Vibration at Idle in Drive

YEAR(S)	MODEL(S)	ADDITIONAL INFORMATION
2024 - 2026	GX550

REVISION NOTICE

Some 2024 – 2026 model year GX 550 vehicles may exhibit a vibration at idle when in drive. The Engine Control Module (ECM) logic has been modified, in addition to improved exhaust hangers, to help improve this condition. Follow the Repair Procedure in this bulletin to address this condition.

Figure 1.

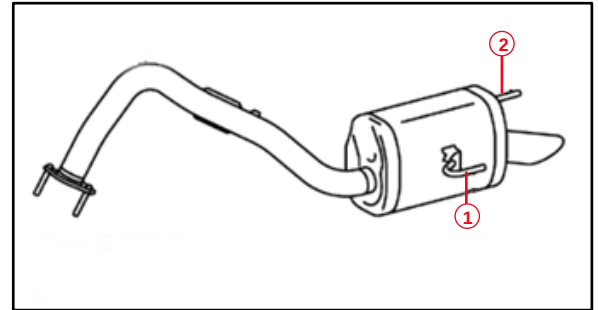
4. Replace the exhaust supports on exhaust hangers three and four found in Figure 1.

1	Hanger 3
2	Hanger 4

Figure 4. Rear Mount

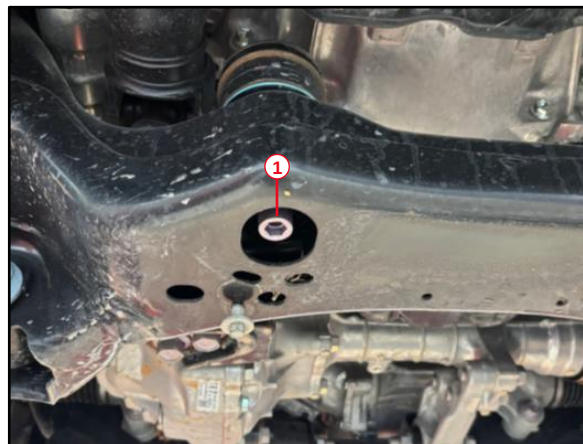
5. Loosen the front differential support points, as shown in Figure 4, Figure 5, and Figure 6.

6. Rotate/move the front differential to ensure proper settling, as shown in this [Example Video](#).
7. Re-torque differential support bolts using proper torque specifications found in Repair Manual.
 - [2024 – 2026](#) GX 550:
Drivetrain – Axle and Differential – Front Differential Carrier Assembly – Installation
8. Confirm vibration at idle condition has improved.
